Fakir Fashion Ltd (Extension 2)

Dohargaon, Baliapara, Rupgonj
(23.785597, 90.587278)

27th August 2019

Observations

Column Layout plan

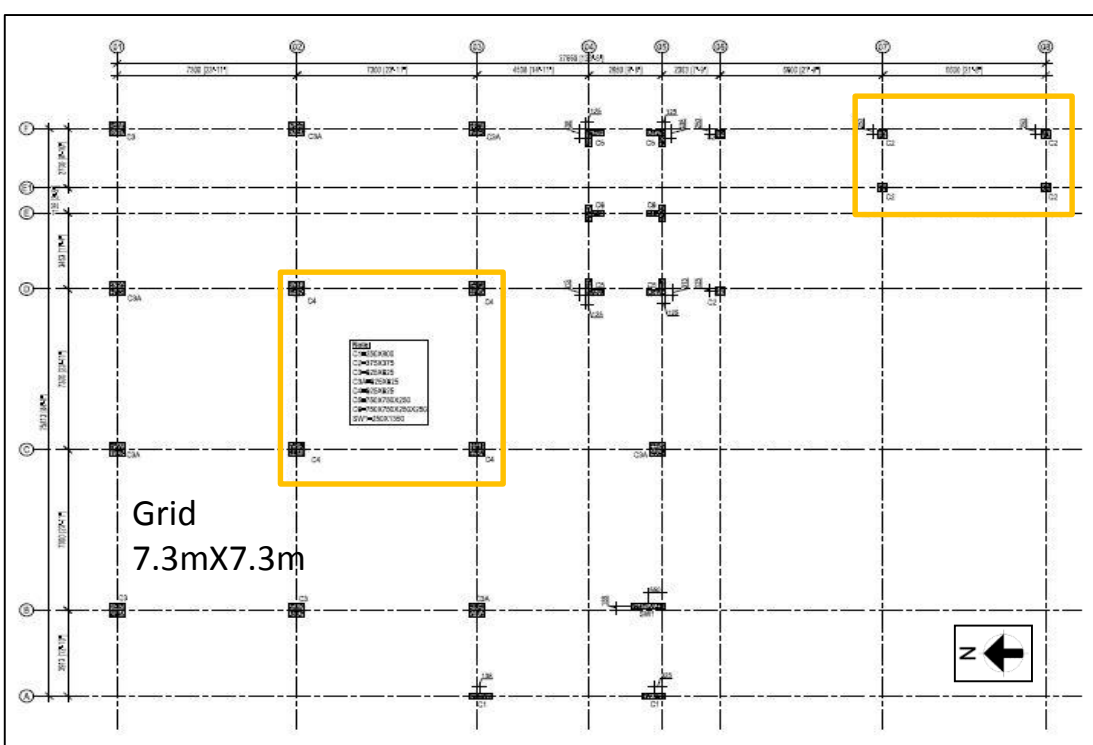
**Columns are stressed above normal design limit
considering prepared load plan**

Cursory calculation indicates that the marked columns are stressed above normal design limit considering prepared live load plan of 5 kPa and assuming minimum concrete strength of stone chips. Building engineer is required to review design, load & column stress in the area identified above.

24.1 MPa (3500 psi) concrete strength mentioned in general note. Calculation and sufficient test report not present during inspection.

5 kPa live loading observed. Also considered in Load Plan

5000L water tanks with 200 mm additional slab

Cracking in cantilever beam & slab

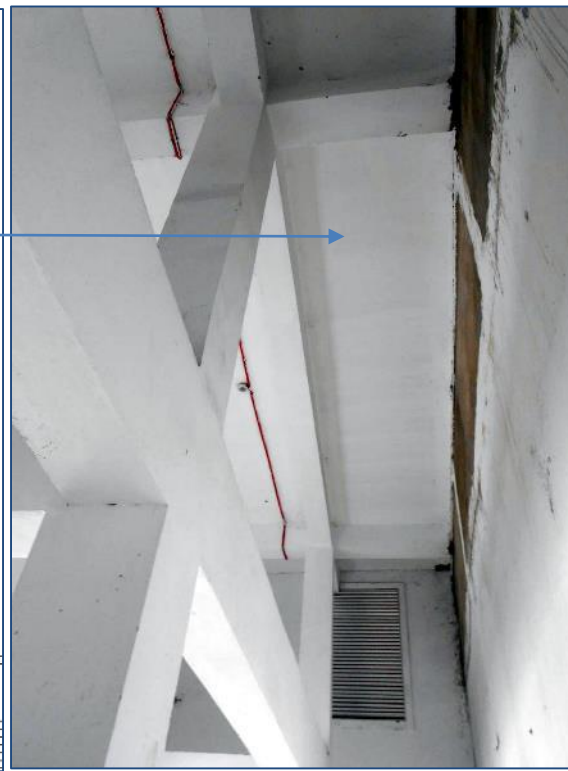
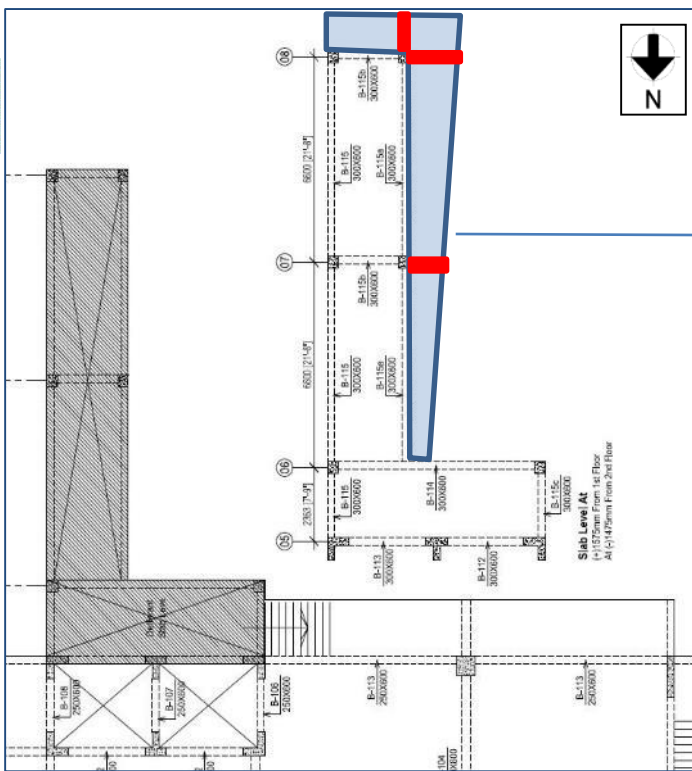
Cracks observed in cantilever beam and slab. Building Engineer to check the extent of the cracks.

Damage at column edge

Damaged column observed on ground floor area. Building engineer is required to check the extent of damage and suggest required remedial works considering possible impact loading.

Column Layout

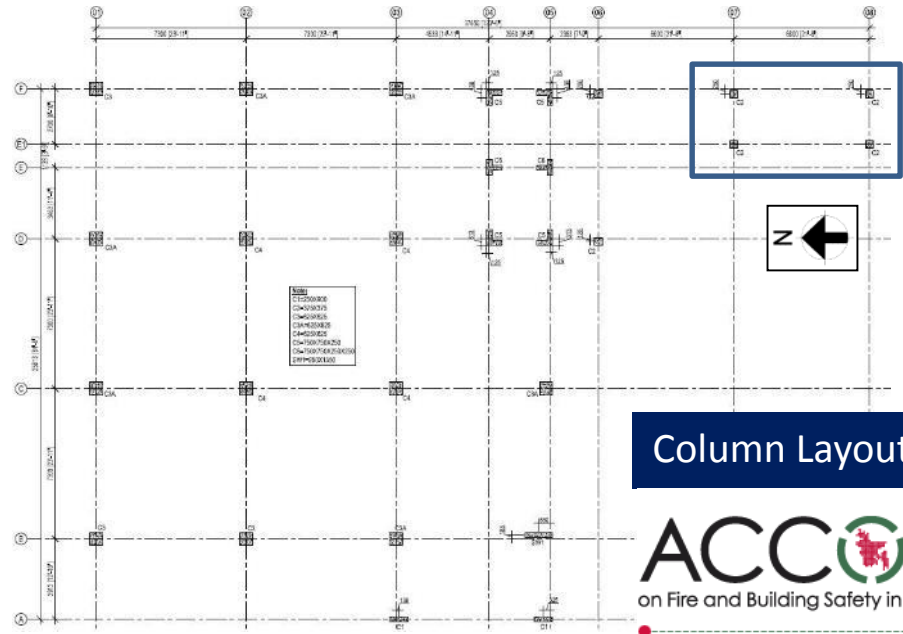
There are anomalies between as-built drawings and as constructed structure for the cantilever slab outline and beam. Also, rebar in C2 type column was found less than shown in column schedule. On one face, the number of rebar was found 3 instead of 4.

Column Layout

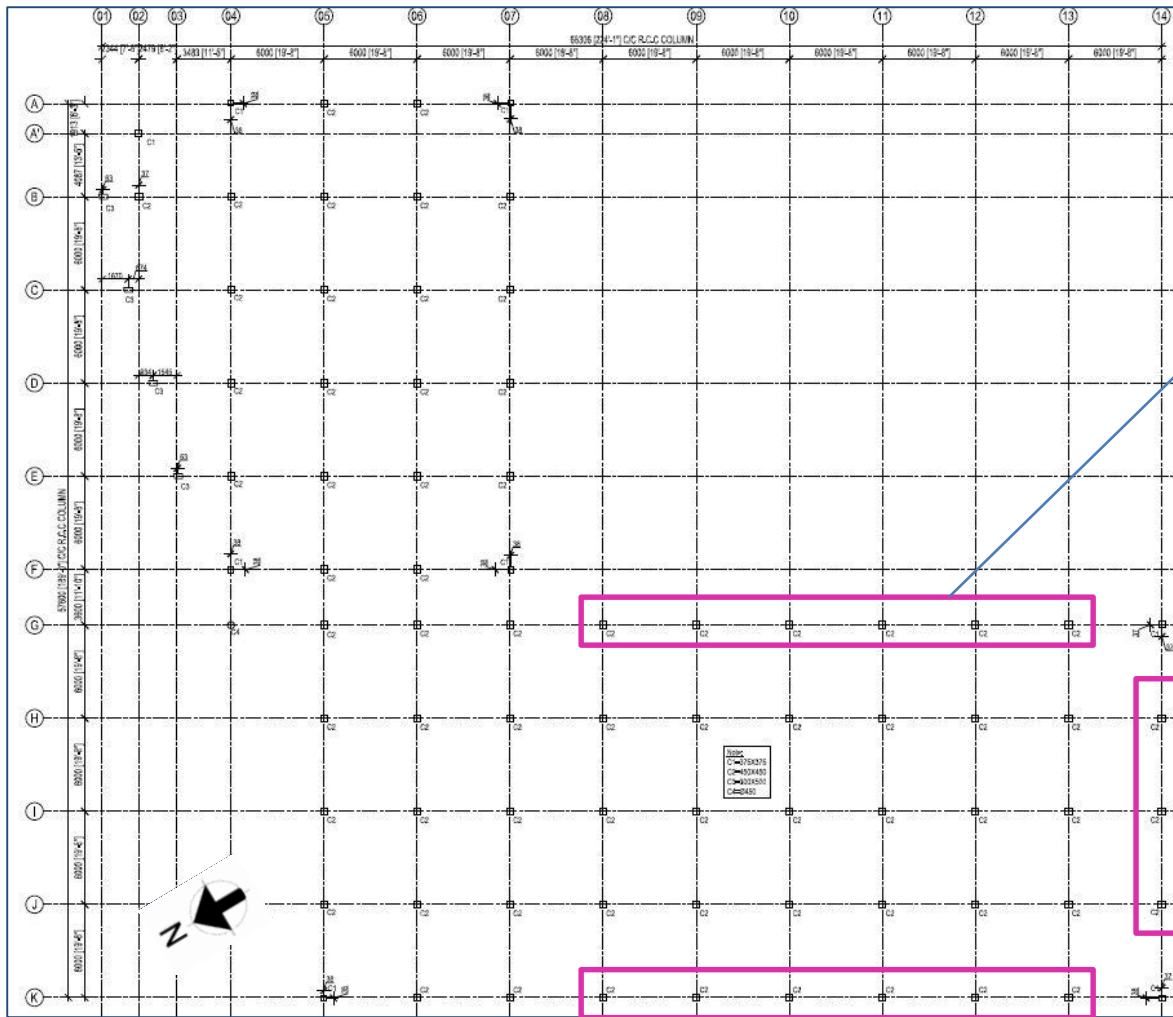
Rebar number of exterior column, (C2 type) was found less than mentioned in column schedule. On one face, the number of rebar was found 3 instead of 4.

12	Discrepancies in as-built drawings.(Building 7)	Factory engineer is required to survey all the structural elements properly and produce correct as built drawings.	6-weeks
13	Discrepancies in as-built drawings.(Building 7)	If the number of rebar found less than the actual design, building is required to review the design & column stresses.	6-weeks
